Addendum 1:

**Sebago Lake State Park
Bathhouses (2), Pole Barn, Entrance Booth, & Amphitheater Upgrades
BGS project number: 3637**

**Addendum 1:
Bid Clarifications and Responses to
Bidder Requests for Information (pre-Bid RFIs)**

**Sebago Lake State Park
Bathhouses (2), Pole Barn, Entrance Booth, & Amphitheater Upgrades
BGS project number: 3637**

7
ASK-001.1 SCALE: 1" = 1'-0"

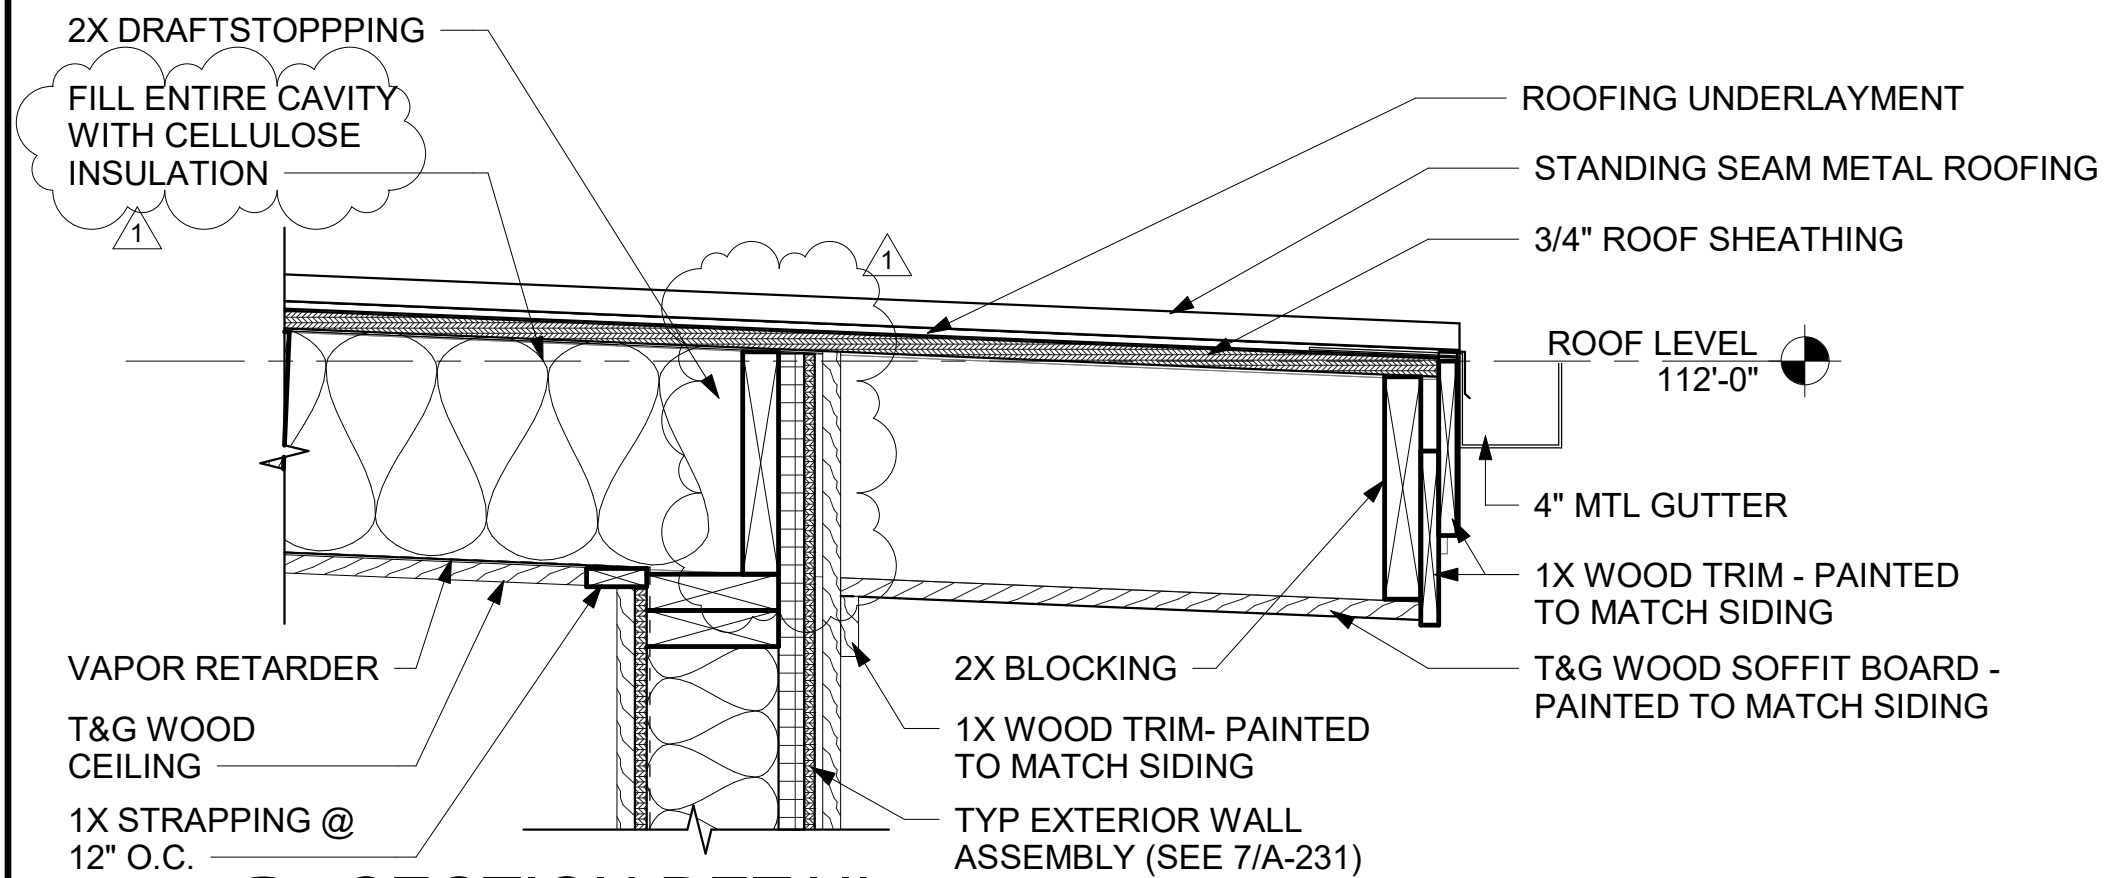
RFI 2: Entrance Booth - We would...typically avoid installing R-29 Densepack in an unvented Roof Cavity (unless you plan to vent it above the sheathing). This configuration is an invitation for moisture issues and does not meet code. I also don't understand why they are bothering to specify the R-6 Continuous at the outside of the Exterior Walls when not insulating the roof to code.

Response: See attached updated details. The bid set documents are code compliant per the relevant codes and their applicability for the Entrance Booth Project.

REPLACES SECTION 7/A-231

KS-1

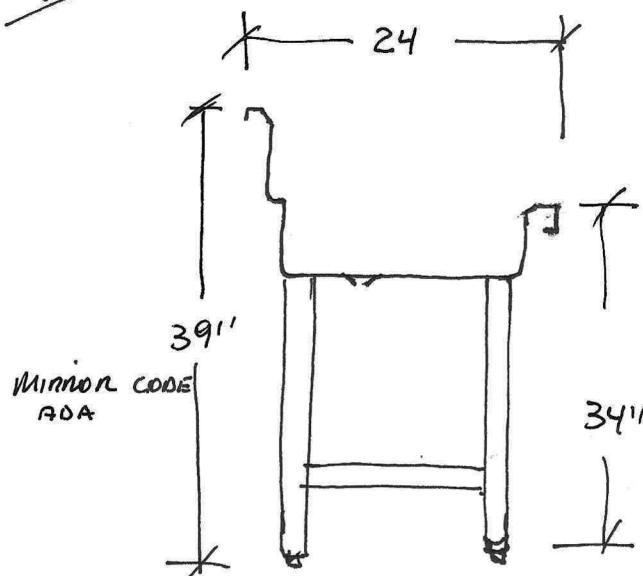
RFI 10: Are there any details on dishwashing stations? Countertop type? Brackets?

RFI 11: The sink is labeled for dishwashing but it doesn't call out anything for what the countertop is and how its built?

Response: The requirements for the exterior sinks are per the plumbing fixture schedule on drawing P-601; refer to tags KS-1, and KS-1A.

Response: The countertop is integral to the sink/backsplash and constructed of stainless steel; refer to the attached sketches for basis-of-design information; contractor is to submit shop drawings for review and approval by the owner and engineer.
